REVISED NOTICE OF HISTORIC REVIEW BOARD DECISION

FILE NO.: MD 17-01, MD 17-02, MD 17-03, MD 17-04, MD 17-05, and MD 17-06:
Historic Review for the designs of six (6) cottage style homes in the Canemah Historic District.

REQUEST: The applicant is requesting design approval for the construction of six (6) new construction cottage style dwelling units, with preservation incentives to adjustment the front, side, and rear setbacks, in the Canemah Historic District.

Proposed House 1:

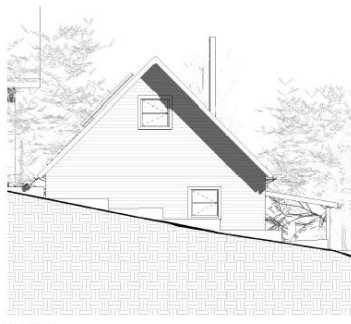
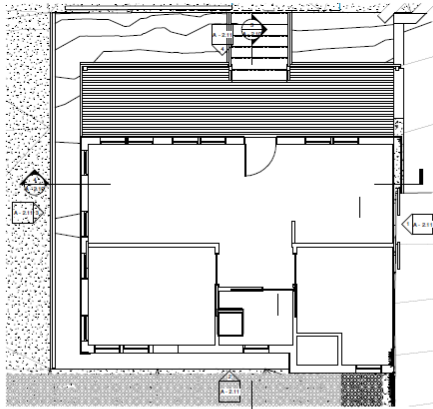
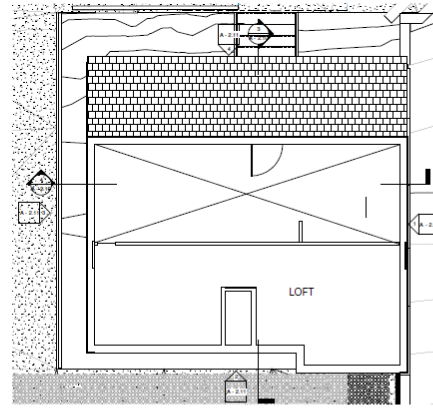
In the design of home number one, the applicant has indicated that they are planning to remove a significant portion of the abutting topography, creating a cutout for the home and a twelve (12) foot wide driveway on the existing lot. This home will also be located directly upon the east property line.

The proposed landscaping in front of the front of the home is unclear. The applicant will need to go through Geotechnical Review along with Site Plan and Design Review.

- a. The house shall be repositioned on the site so the proposed home meets the setback standards of the underlying zoning district.
- b. Retaining and structural walls shall be minimized; to be faced or finished in stone, mortared basalt, or concrete, and not exceed 3 ½ feet, to complement the Canemah Neighborhood.

- c. Concrete foundations shall have a natural, parged or painted finish.
- d. Exposed foundations shall be site screened with vegetation if concrete or masonry exceeds 3½ feet, or if pilings or posts are 1½ feet above grade.

- e. A minimum of 5 shrubs and groundcover shall be installed along the façade of the front porch.
- f. Roofing shall use traditional materials such as wood shingles, composition, and metal shingles.

- g. Skylights shall be installed in inconspicuous roof slopes and skylights shall be mounted close to the roof plane, and not visible from the right-of-way.

Proposed House 2:

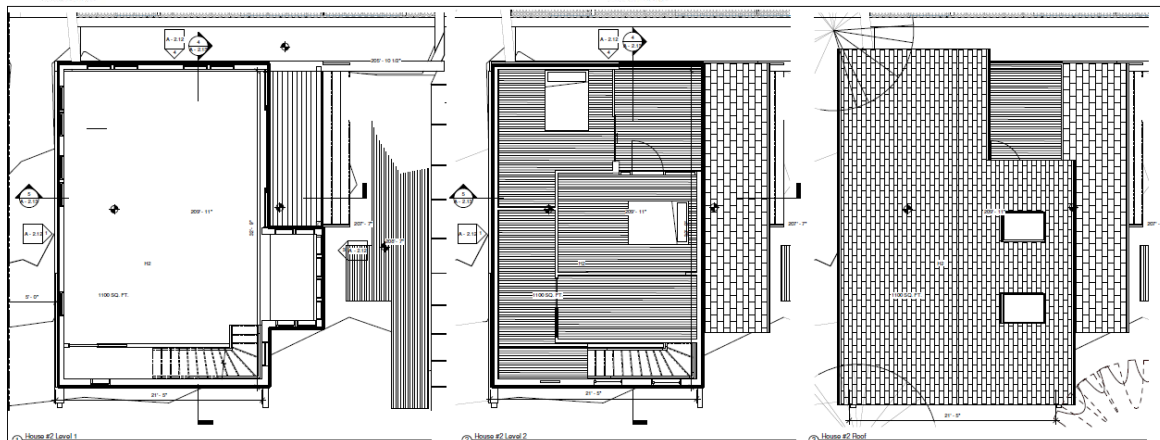
2. House number #2 on the submitted site plan shall be removed from the site, and the proposed cottage home development shall consist of five (5) cottages total. (P)

- a. House #2 shall be removed from the Cottage House Historic Review Board Design Application.

Proposed House 5:

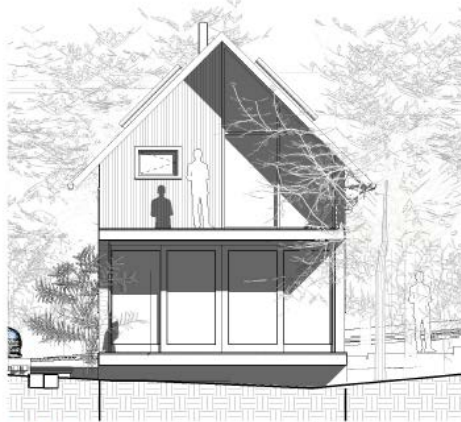
- The applicant shall revise the home with a porch railing on the second story of the home.
- The porch shall consist of simple trim at base and top, consistent with architectural style.

- a. The main entrance of the house shall not be oriented towards the adjacent parking lot.
- b. Windows shall match the member sizing, thickness and shadowline of painted wood windows. Windows shall also consist of the following designs: double, single hung, or casement. Wood clad shall be matching in color and finish. Non-wood fiberglass and aluminum windows are acceptable if in appropriate style, and matching wood in profile, shadowline, and if similar in

- c. Residential doors shall complement the design and detailing of the historic style with similar appearance to wood. Doors shall be designed in a stile and rail type; panel design; with upper portion glass. The primary door may be a solid panel door. Sliding doors are not permitted on any portion of the house.

- d. Gable roof slopes shall have equal pitch. Gable primary roofs shall have a pitch of 8:12 or greater (6:12 for Bungalow). Porch or bay roofs may have lower slope, may have hip if style allows. Roofs shall have a minimum 1 foot overhang with a maximum of 3 feet.

- e. Concrete foundations shall have a natural, parged or painted finish.
- f. Exposed foundations shall be site screened with vegetation if concrete or masonry exceeds 3½ feet, or if pilings or posts are 1½ feet above grade.

- g. The applicant shall revise the home with a porch railing on the second story of the home.
- h. The porch shall consist of simple trim at base and top, consistent with architectural style.

- i. Roofing shall use traditional materials such as wood shingles, composition, and metal shingles.
- j. Skylights shall be installed in inconspicuous roof slopes and skylights shall be mounted close to the roof plane, and not visible from the right-of-way.
